CITY COUNCIL STAFF REPORT SUPPLEMENTAL 1

Meeting: January 22, 2025

Agenda Item #8

Award a construction contract to Golden Bay Construction in the amount of \$1,569,798, approve a first amendment to the design services contract with Pakpour Consulting Group to increase the contract by \$96,620 for a total not-to-exceed contract amount of \$310,483 and approve a budget modification in the amount of \$1,500,000 for the Stevens Creek Boulevard Class IV Bike Lane Project.

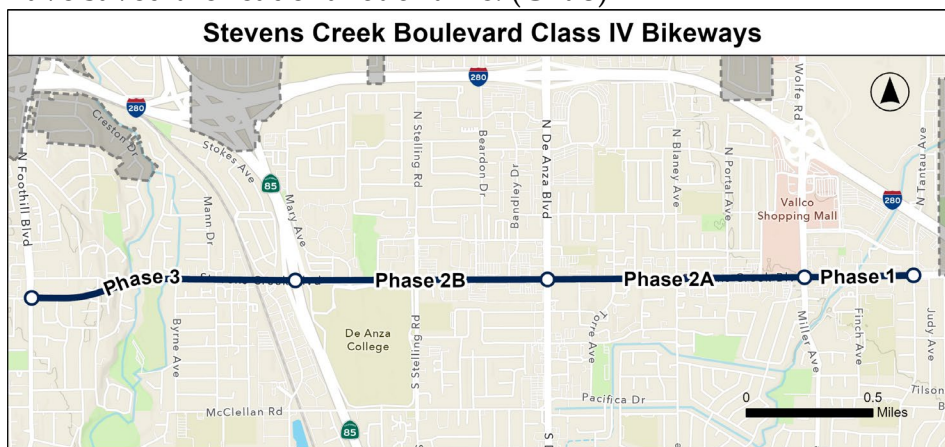
Q2-1: Will the Class IV Bike Lane in Phase 2 include concrete separators, as in McClellan Road, or the bollards, as in Phase 1 in Stevens Creek? I did not find the answer in the staff report. A Google search results in: "A Class IV bikeway, also called a "separated bikeway," is a bicycle facility on a street that is physically separated from vehicle traffic by a vertical barrier like a curb, bollards, planters, or other elements, essentially creating a protected bike lane

where only cyclists can use the space." Please provide a picture of the kind of separators that will be used. A picture is worth a thousand words. **(Chao)**

Staff response: Concrete buffers will be constructed, identical to those currently installed on Stevens Creek Blvd. between Wolfe Road and Tantau Ave. A picture is shown below.
